PROJECT Kercheval Streetscape

SUBMITTAL NO. 09 - Planter Rail

DESCRIPTION Planter Rail

KERCHIVAL
STREETSCAPE - PLANTER
RAIL SHOP DRAWING

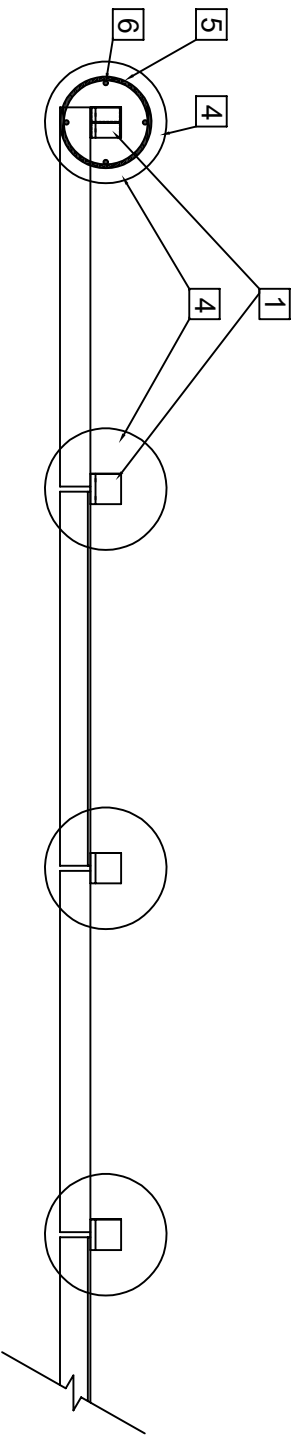
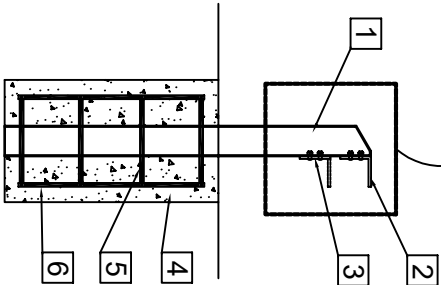
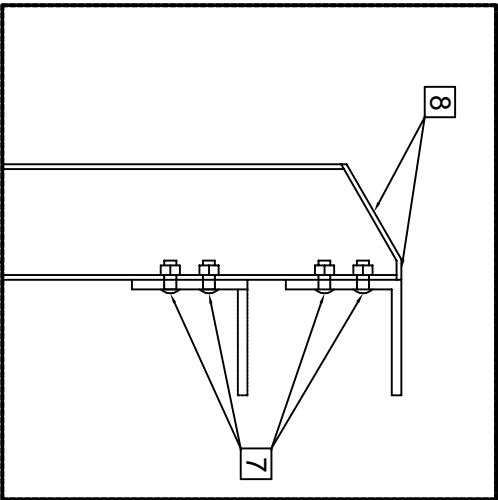
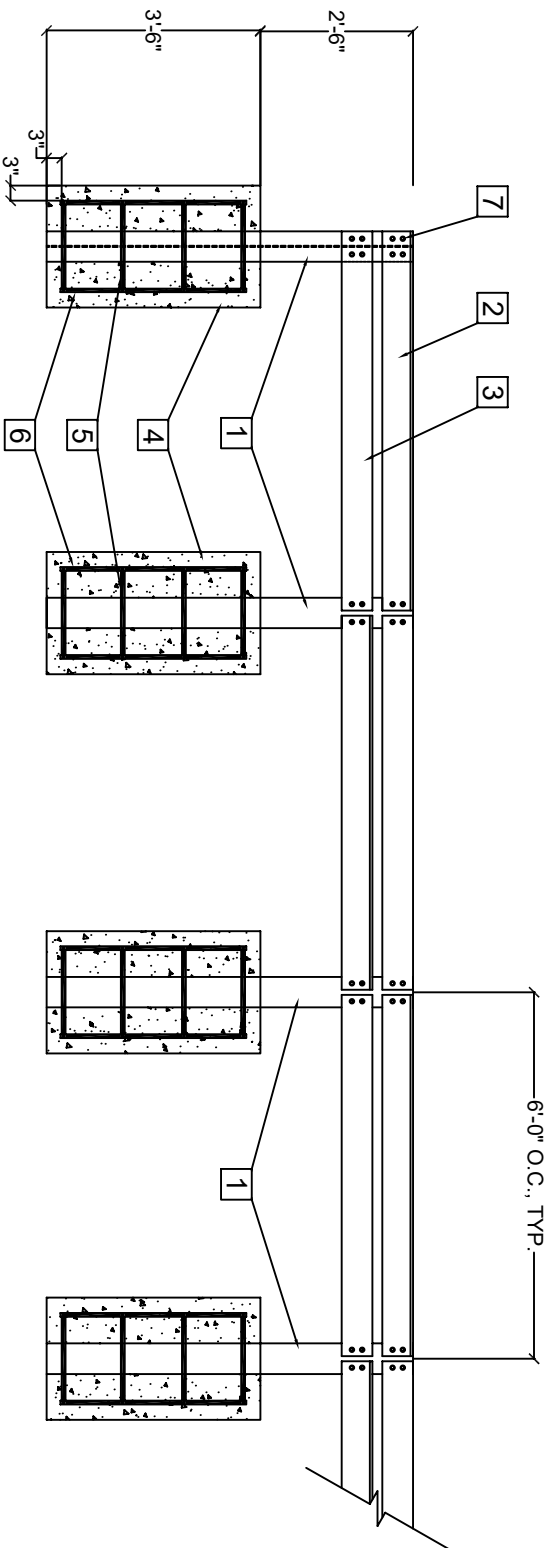
- Field verify railing locations and orientations with Engineer prior to proceeding with fabrication.
- Field verify site conditions and as-built dimensions of proposed planter rail locations prior to fabrication and installation.
- Finish paint color to be "Matte Black" submit color sample as separate submittal for review and approval.
- Cast-in-place footings to be 2' dia. by 3'-6" depth from finish ground surface
- Vertical 6"x6" HSS post to terminate 6" before bottom of concrete footing
